Subject: **ABENGOA MOJAVE SOLAR 09-AFC-5**

ENERGY COMMISSION STAFF'S ERRATA TO THE SUPPLEMENTAL STAFF ASSESSMENT PART B – BIOLOGICAL RESOURCES SECTION

BIOLOGICAL RESOURCES - FIGURE 2

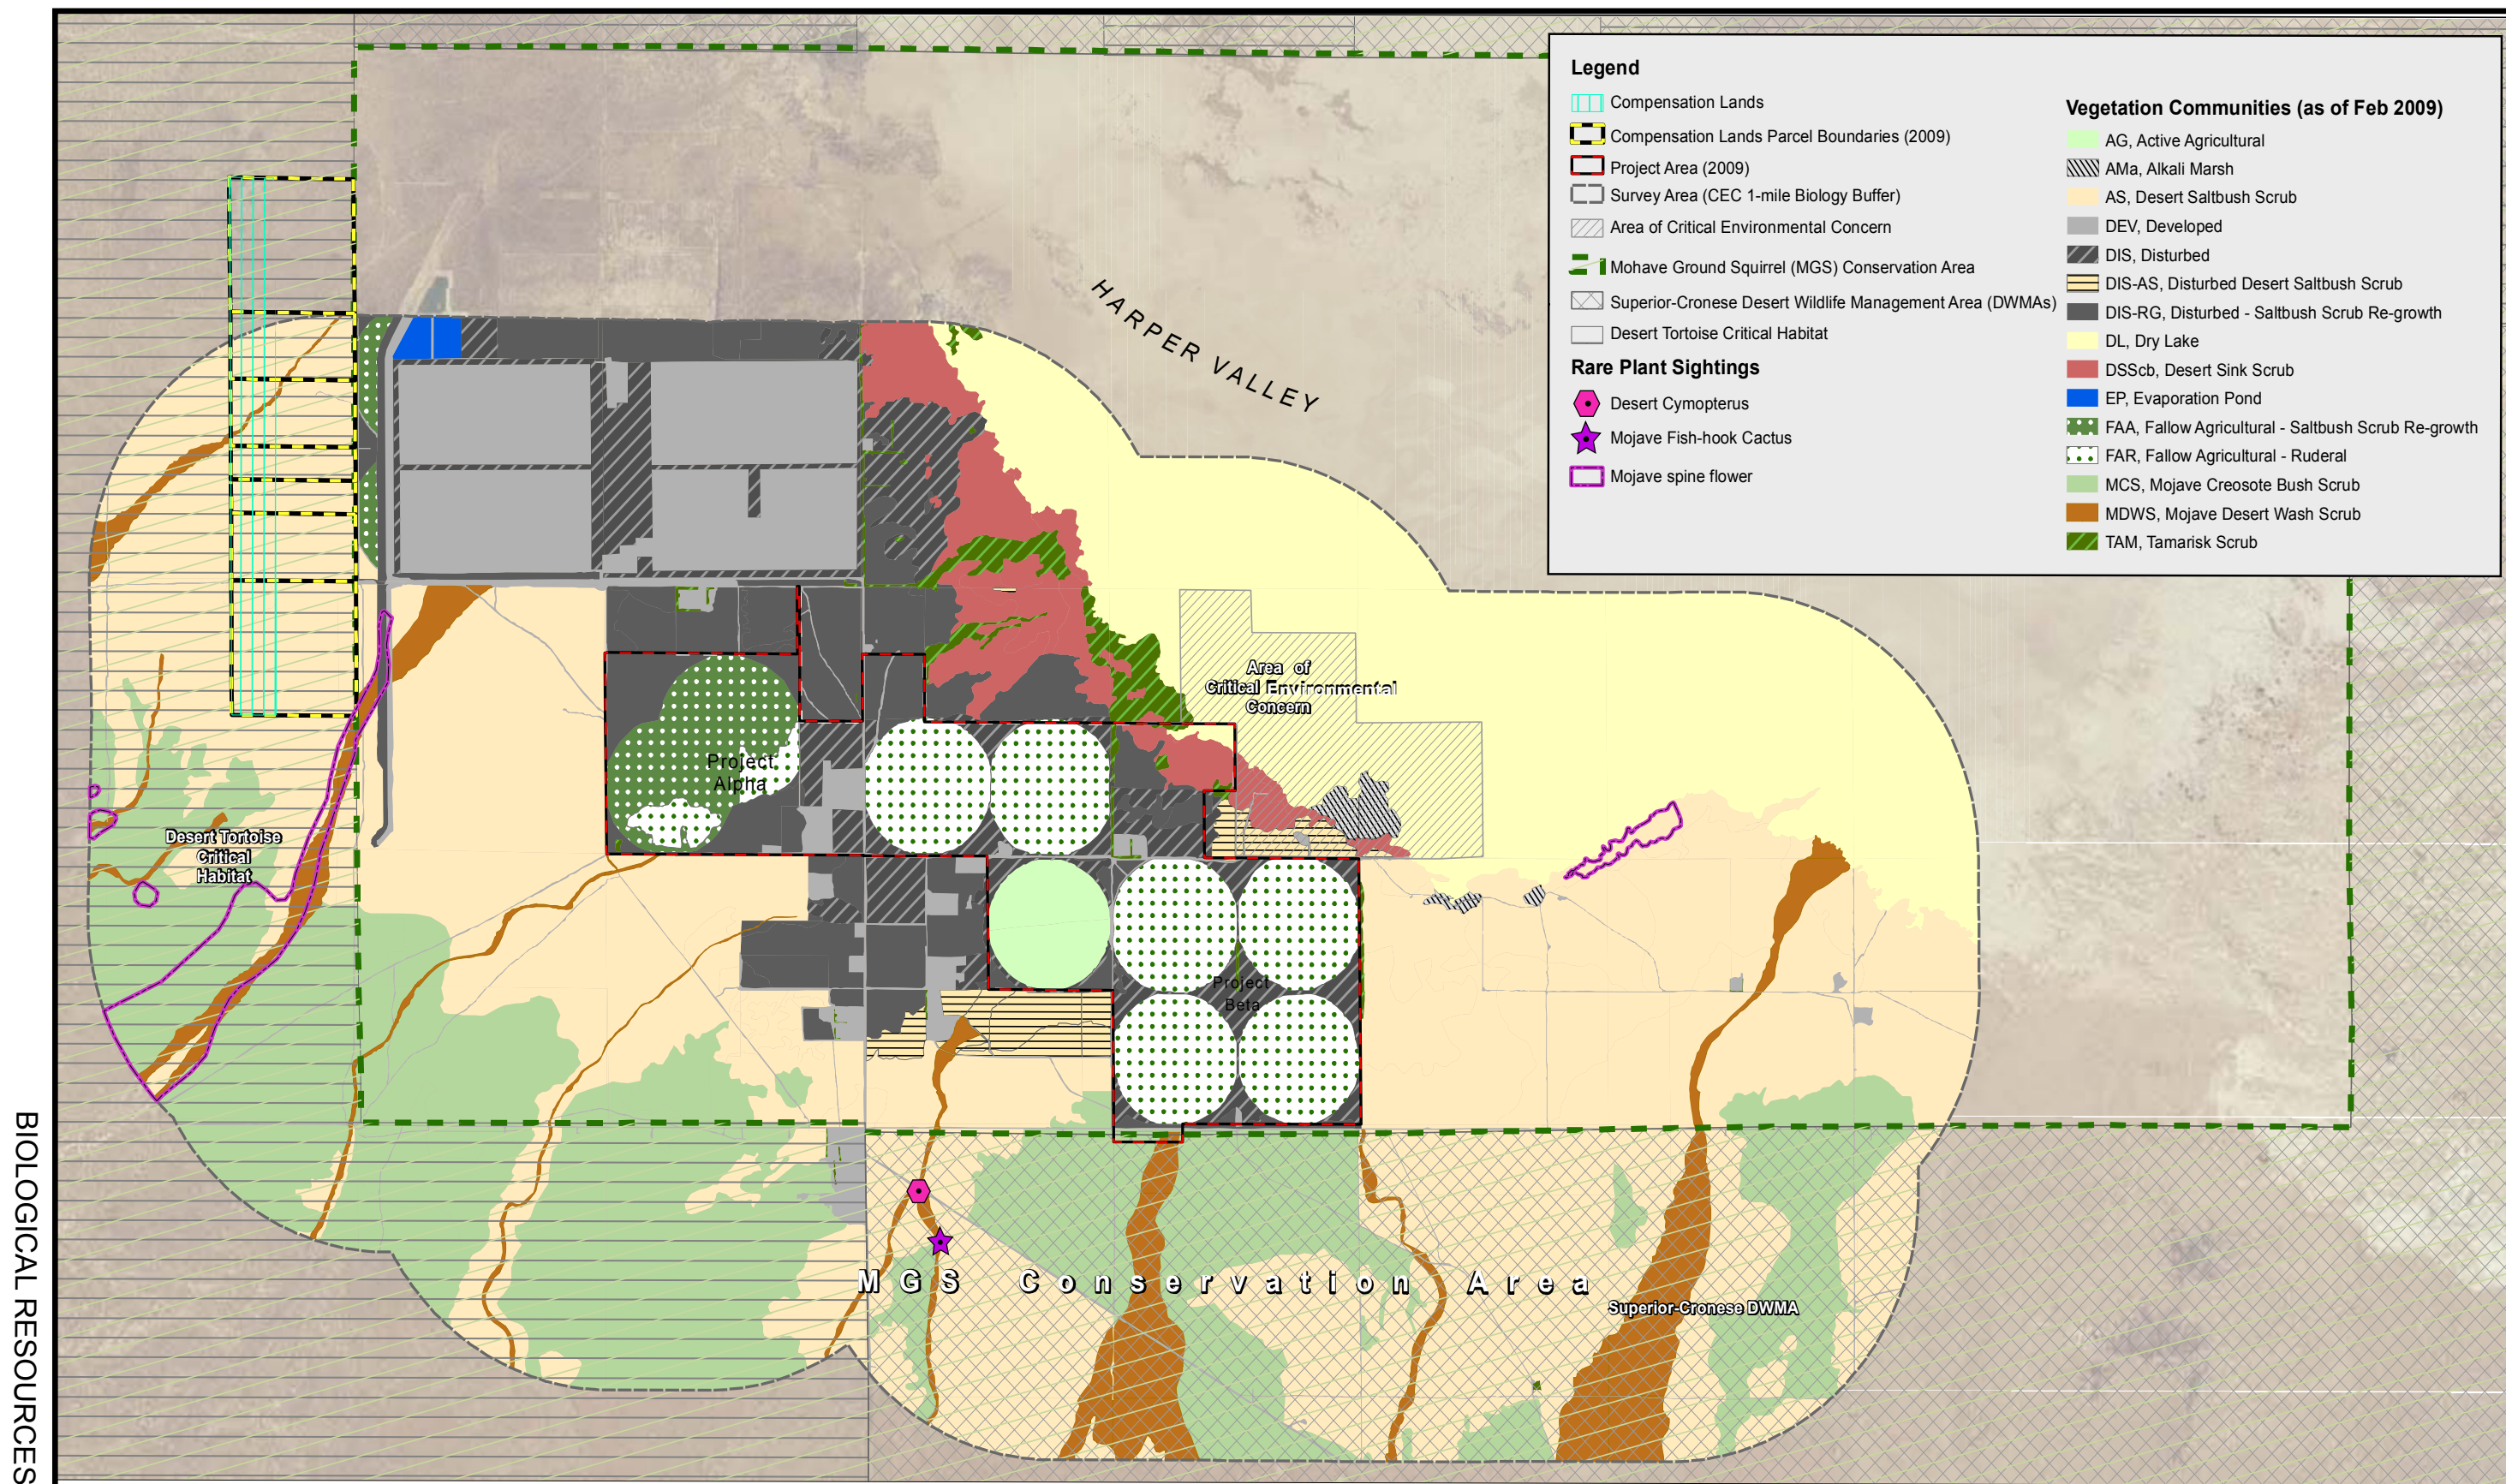
Energy Commission staff is providing an Errata to the Biological Resources section of the Supplemental Staff Assessment Part B. The attached Biological Figures 1 and 2 are intended to replace what is included in Supplemental Staff Assessment Part B. The attached figures were previously included in the Staff Assessment dated March 15, 2010 and should have been in the Supplemental Staff Assessment Part B.
